Pulaski County Schools
Energy Savings and Performance Contract
Addendum #2
March 25th, 2022

CMTA Contact:	Megan Brangers
Email:	MBrangers@cmta.com
Cell Phone:	502-919-1521

The following information supersedes or is in addition to information released in the Contract Documents dated March 11th, 2022 and addendum 1 dated March 18th, 2022.

E1-
3.1A

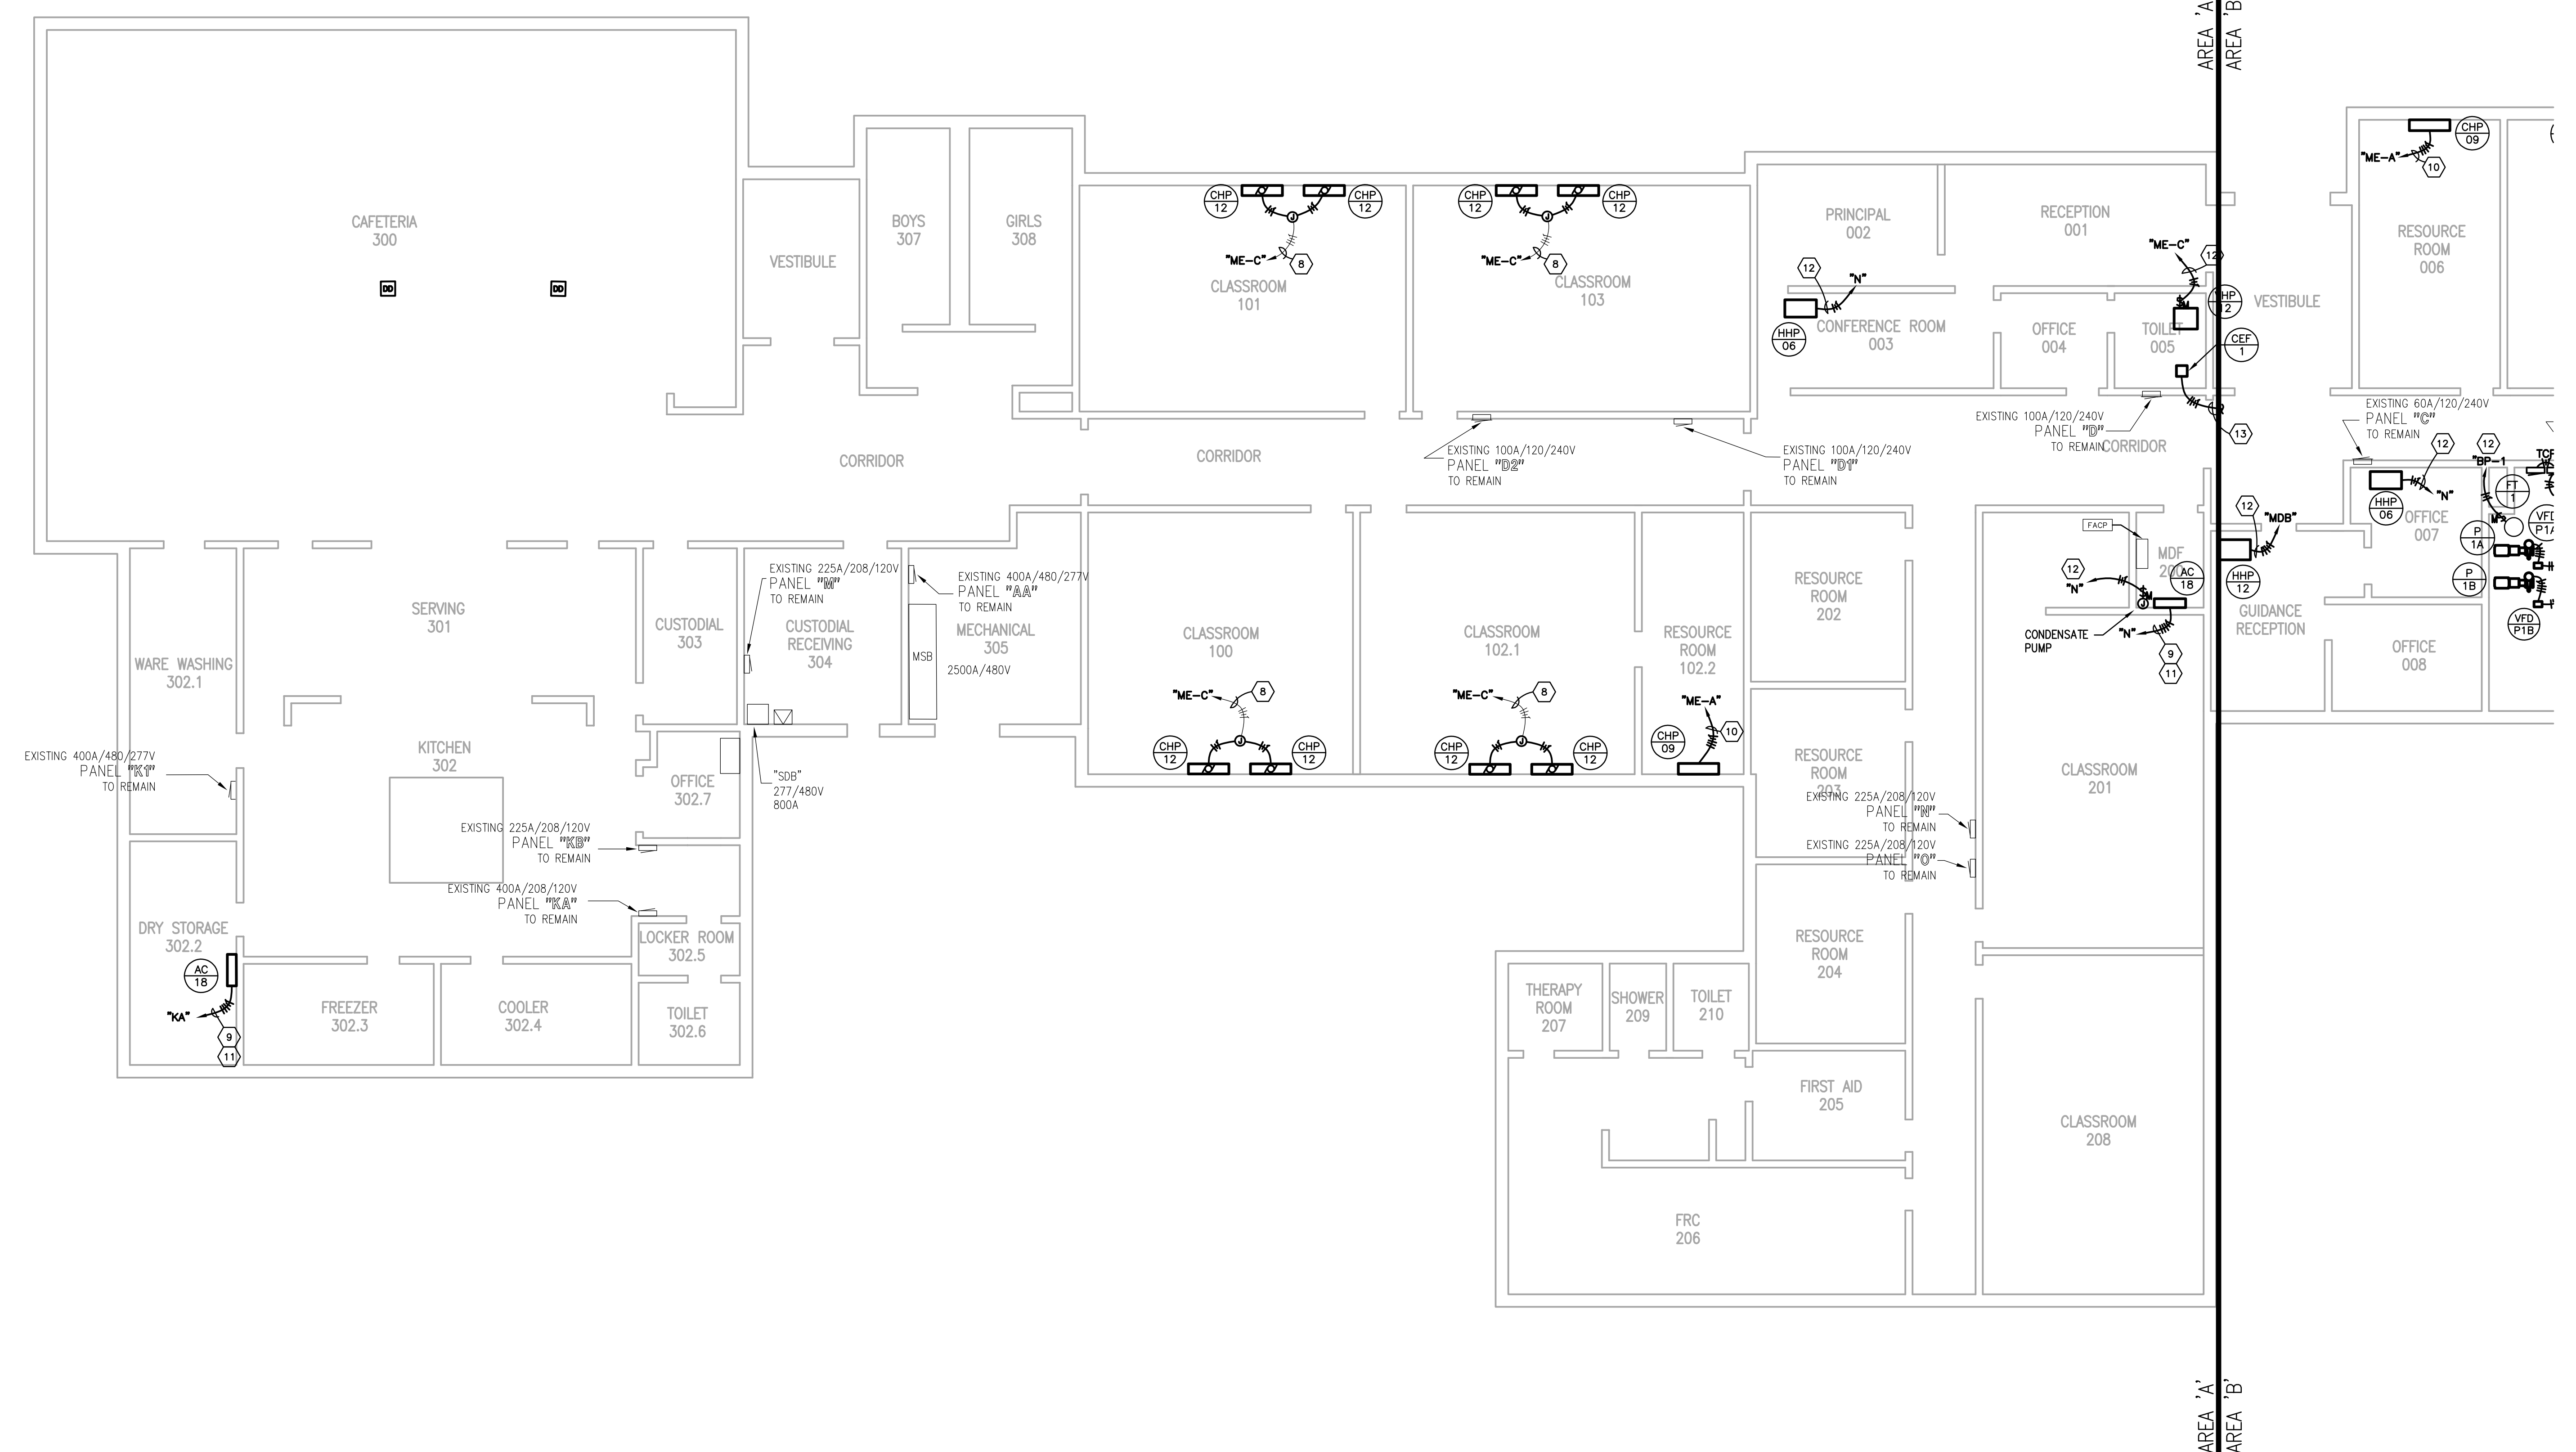
1. Drawing E1-3.1A
 - a. Refer to revised drawing.
 - i. Conductor quantity updated for 3P circuits – see tag notes.
 - ii. Provide connection to condensate pump in MDF 200 as indicated.

- iii. Toilet 005 VHP panel homerun revised.
2. Drawing E1-3.1B
 - a. Refer to revised drawing.
 - i. Provide connections to FT-1 and TCP in mechanical 009 as indicated.

E1-
3.1C

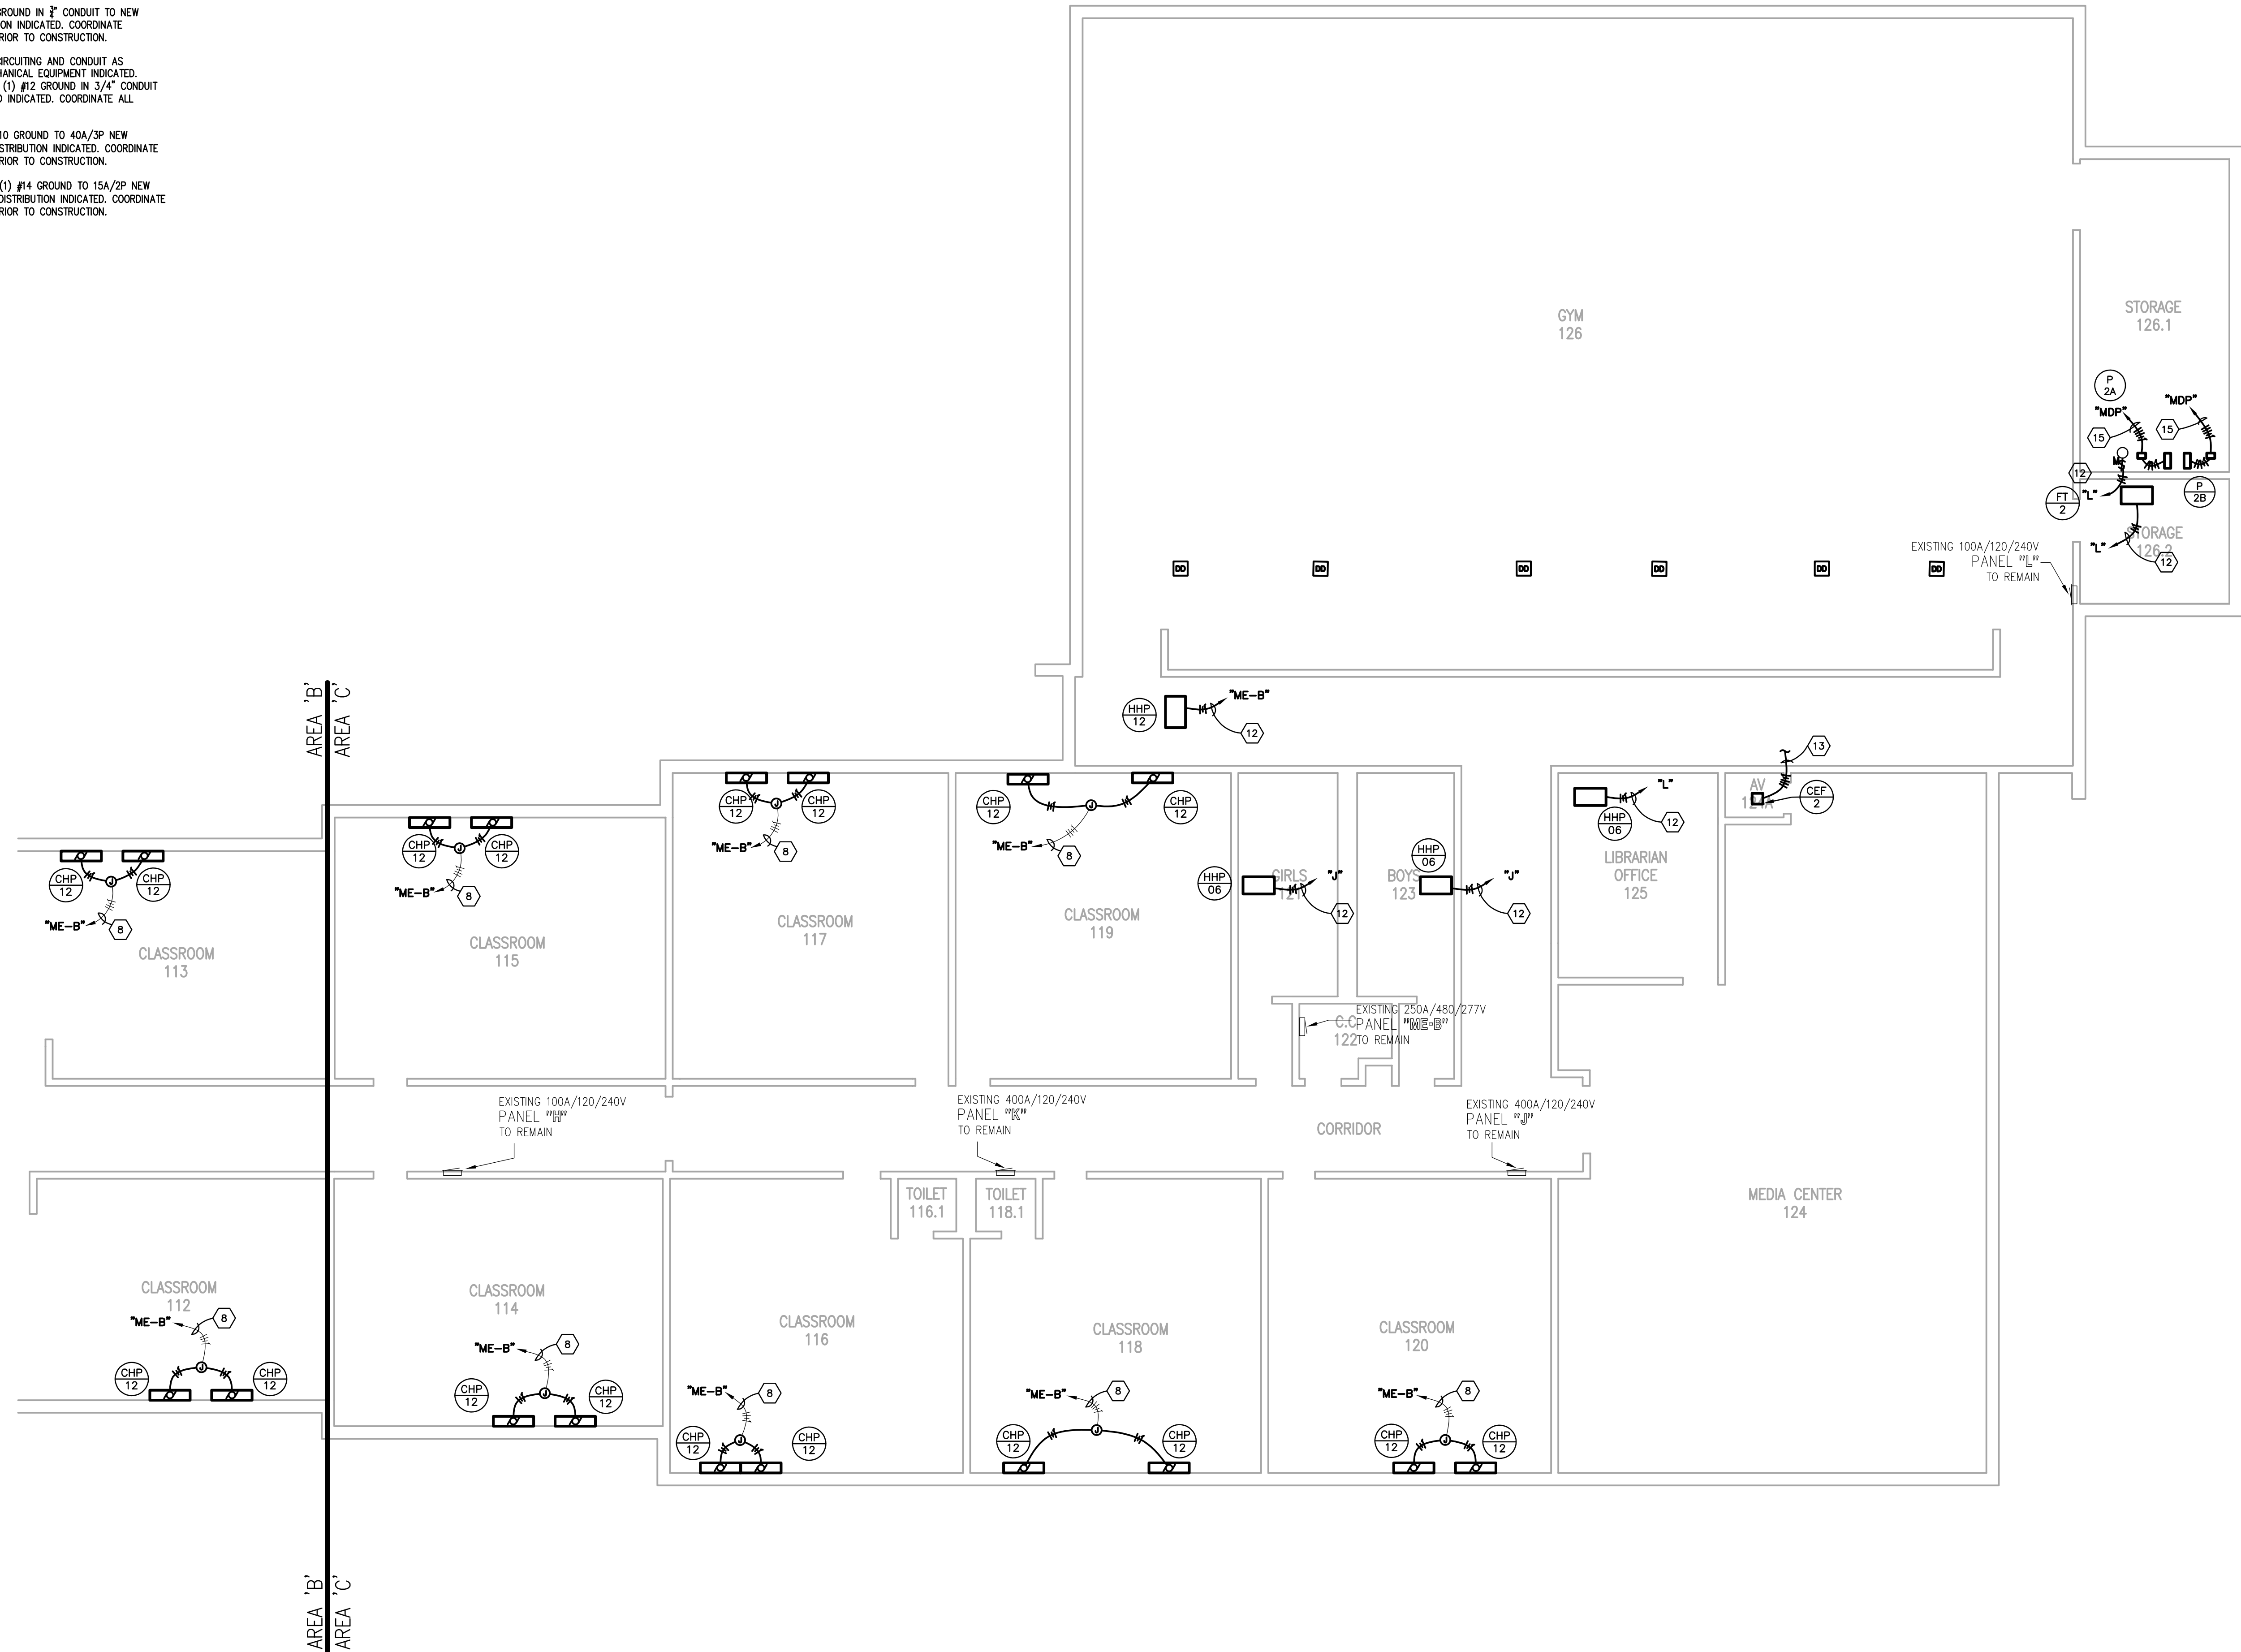
- ii. Mechanical 005 VHP panel homerun revised.
 - iii. Office 007 HHP panel homerun revised.
3. Drawing E1-3.1C
 - a. Refer to revised drawing.
 - i. Provide connections to (1) HHP-12 and (4) HHP-06 adjacent to gym as indicated.

- ii. Provide connection to FT-1 in Storage 126.1 as indicated.
4. Drawing E1-3.2
 - a. Clarification: Refer to floorplan AC unit homerun for CU-18 circuiting.

1
E4-2.1A

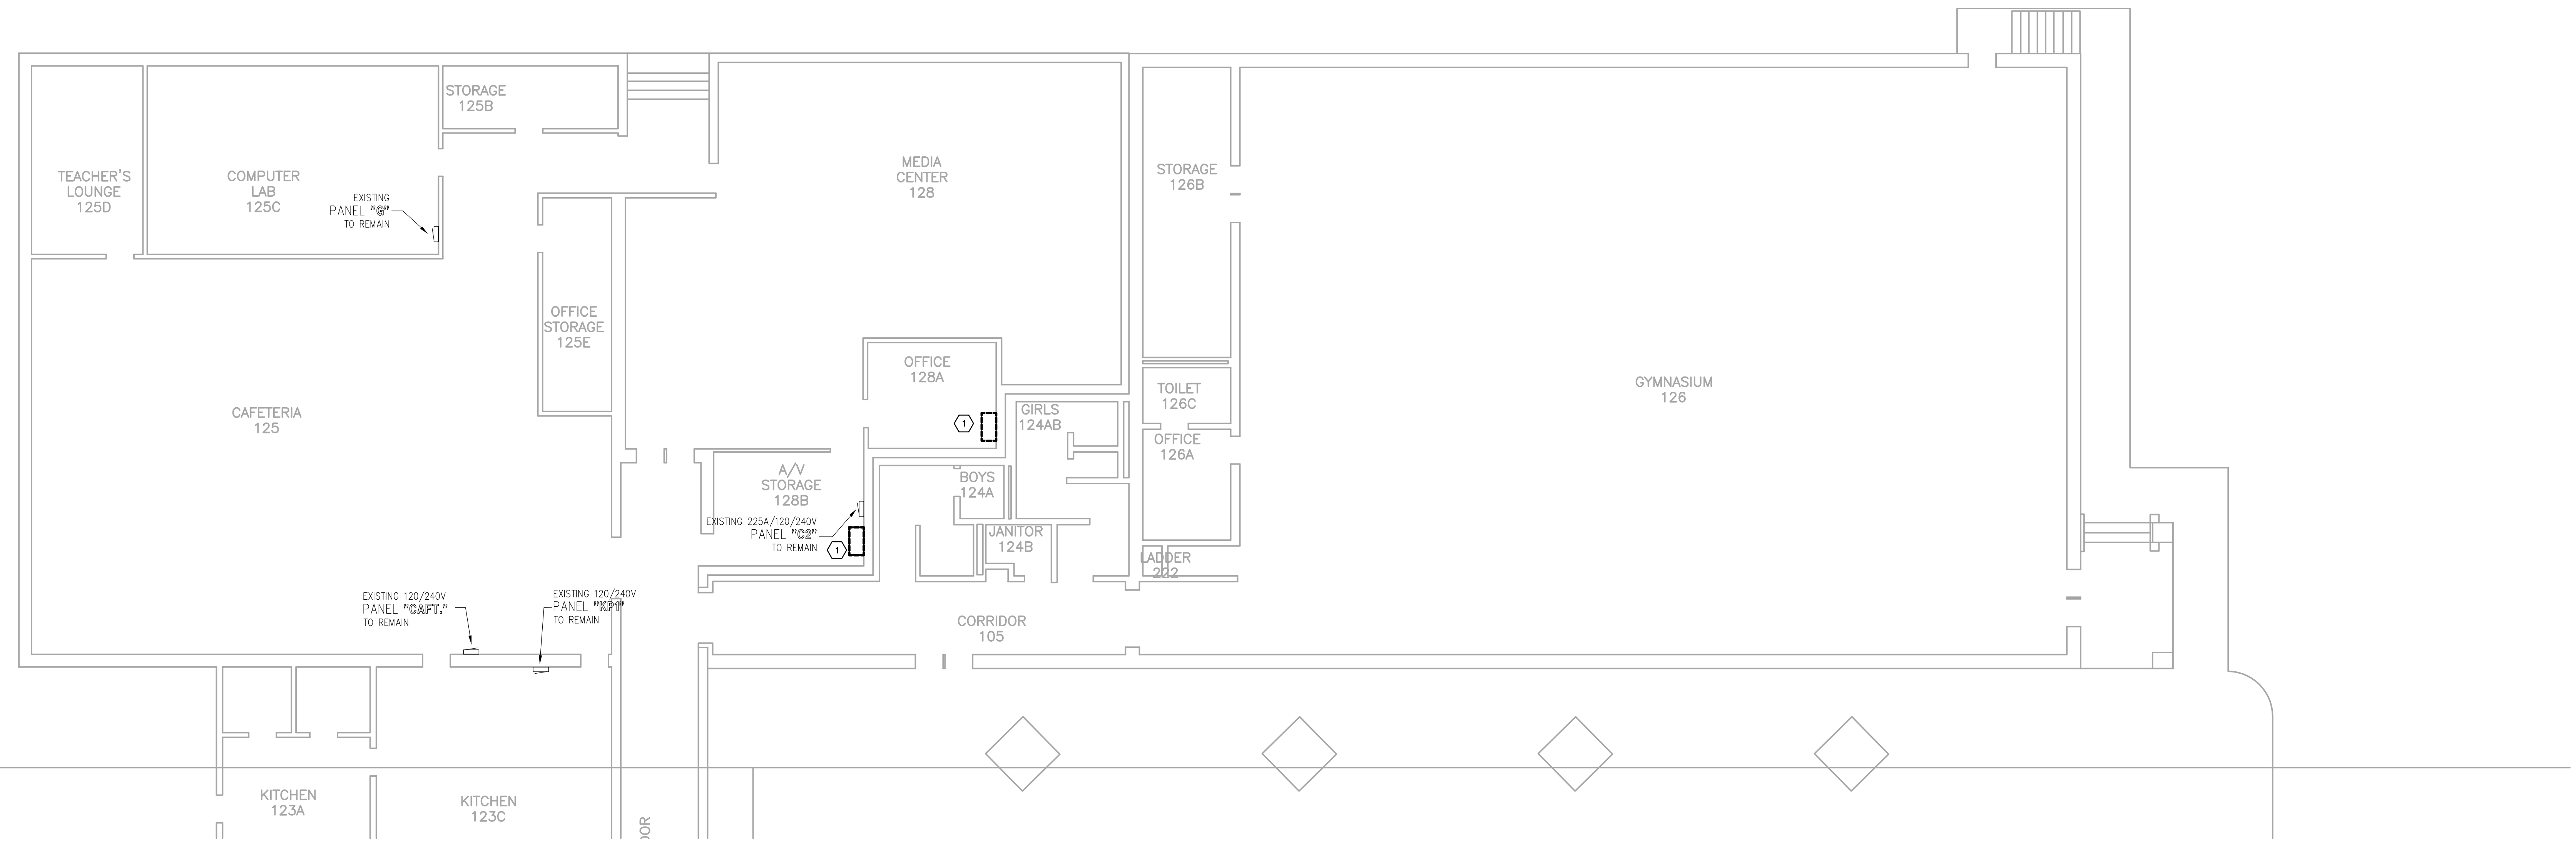
7. Drawings E4-2.1A
 - a. Refer to revised drawing.
 - i. Additional platform equipment demolition indicated.
8. Drawings E4-2.1B
 - a. Refer to revised drawing
